VALUE ENGINEERING REPORT

**SR 166 Bypass, Widening and Reconstruction
STP00-0021-01(024)(025); PI Nos. 0631300 & 0631310
Carroll County**

May 15, 2013

Georgia Department of Transportation
600 West Peachtree Street
Atlanta, GA 30308

Idea No.: E-3c
Client: GDOT
Sheet 2 of 5

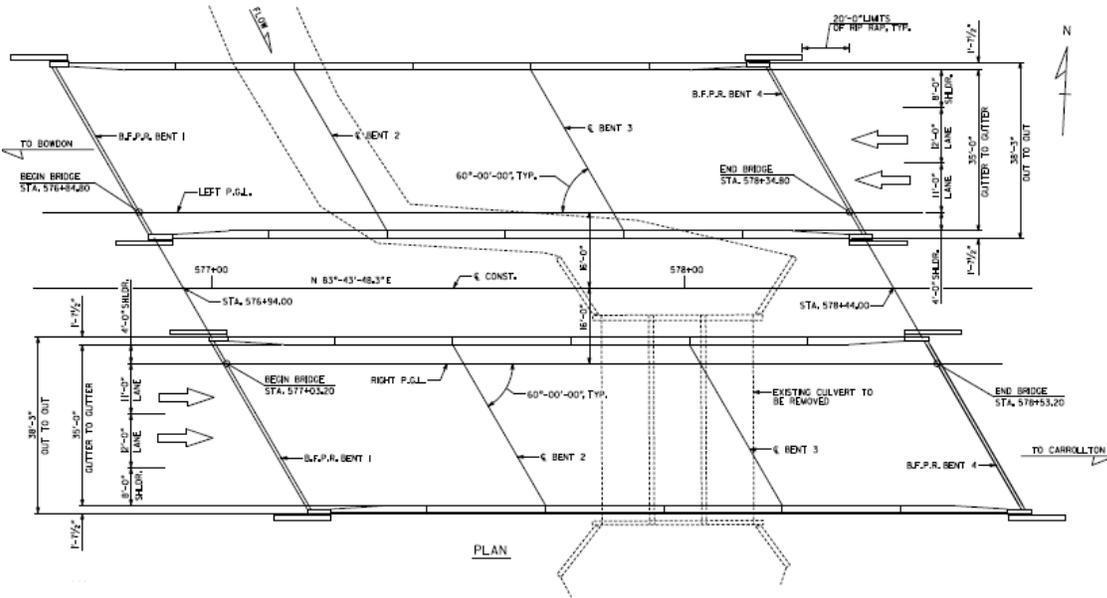
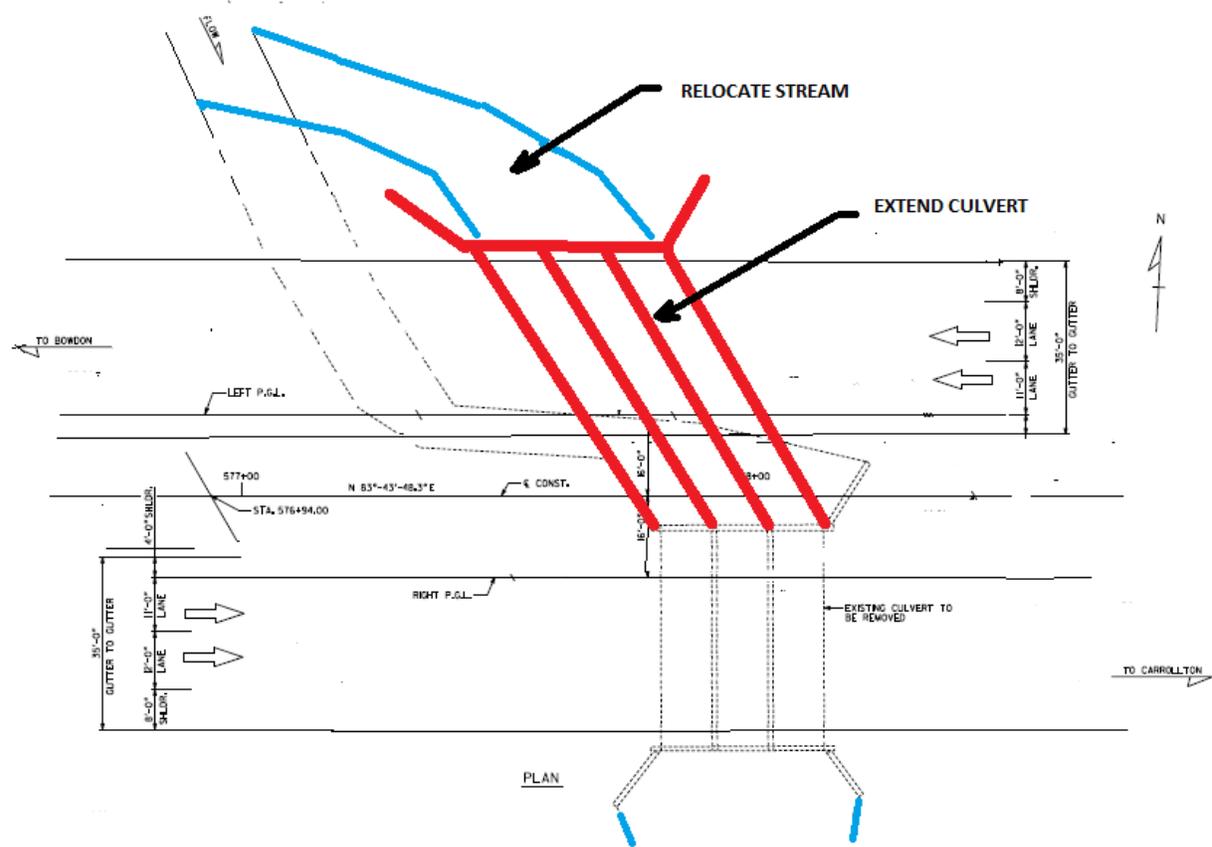
Proposed Change: Retain the existing triple 10x10 concrete culvert and construct a skewed extension under westbound SR 166. This will realign the upstream opening with the current stream alignment but require an angle point at the culvert transition. It will also require stream re-grading and impacts.

Idea No.: E-4a
Client: GDOT
Sheet 2 of 5

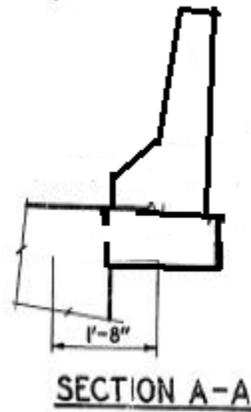
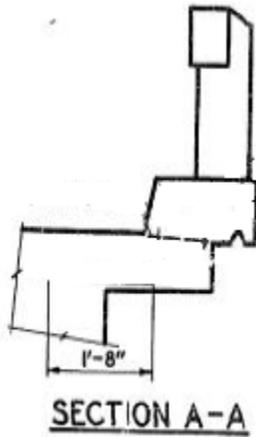
Original Concept: The original concept provides a median opening at Simonton Mill Road. Due to the proximity of the bridge crossing over the Little Tallapoosa River, about 200 feet to the west, a wider structure to accommodate the turning lanes and tapers is required. The current plans provide for a single, combined bridge widening.

Proposed Change: Eliminate this median opening. This will result in constructing only the typical, parallel bridge at the crossing. The existing bridge can remain, as currently proposed with only the side barrier improvements.

Idea No.: E-4b
Client: GDOT
Sheet 2 of 5

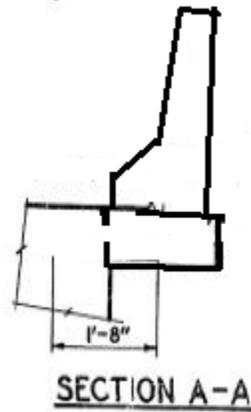
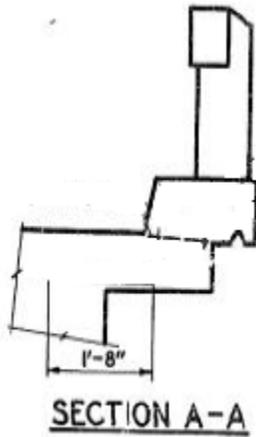
Original Concept: The original concept provides a median opening at Simonton Mill Road. Due to the proximity of the bridge crossing over the Little Tallapoosa River, about 200 feet to the west, a wider structure to accommodate the turning lanes and tapers is required. The current plans provide for a single, combined bridge widening.

Proposed Change: Restrict the access at this location to the east only. Eliminate western access. This will essentially only eliminate u-turn movements by eastbound traffic. This will result in constructing only the typical, parallel bridge at the crossing. The existing bridge can remain, as currently proposed with only the side barrier improvements.
